E3649A-04B**S E R V I C E N O T E**Supersedes:
E3649A-04A**E3649A DC Power Supply****Serial Numbers: MY51240078 to MY99999999****Metal Strap Kit for tightening loose bumper and for fitting rear lock link in side-by-side rack mounting****Parts Required:**

Figure 1: Top view 3mm gap observed between two different chassis designs

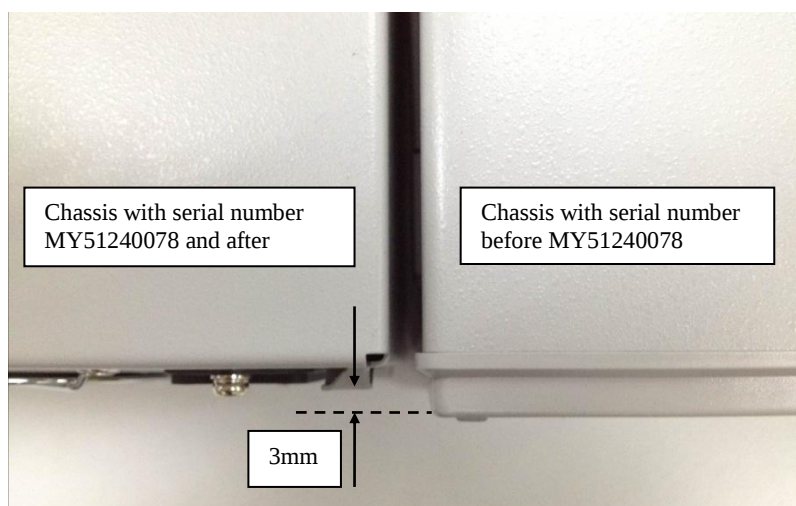
The chassis depth difference between the two designs is 3mm as shown in Table 1 and Figure 1 below.

Figure 2: Top view 3mm gap observed on rear lock link for side-by-side rack mounting

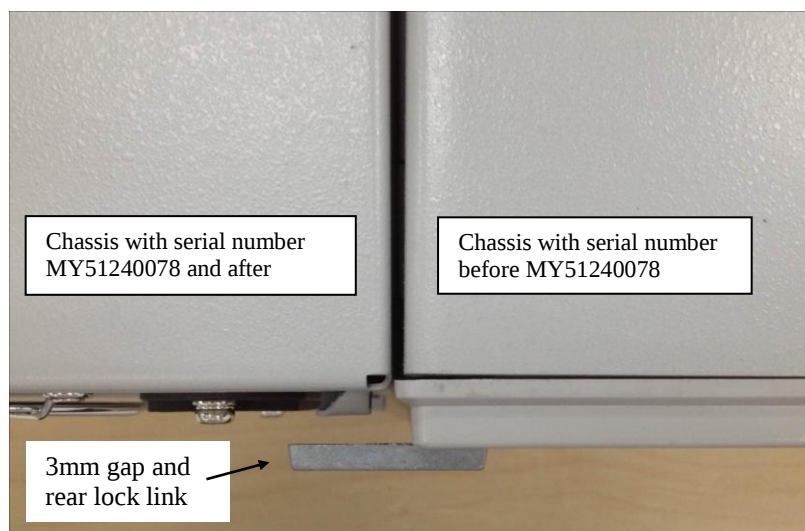
The 3 mm gap between the two different chassis may cause difficulties in securing them together using a rear lock link kit (part number 0050-2167) for side-by-side rack mounting as shown in Figure 2 below.

Use metal strap (part number E3631-07901), and stack the provided two metal straps together to form 3mm thickness and secure it with the provided screws on the rear lock link as shown in Figure 4 below.
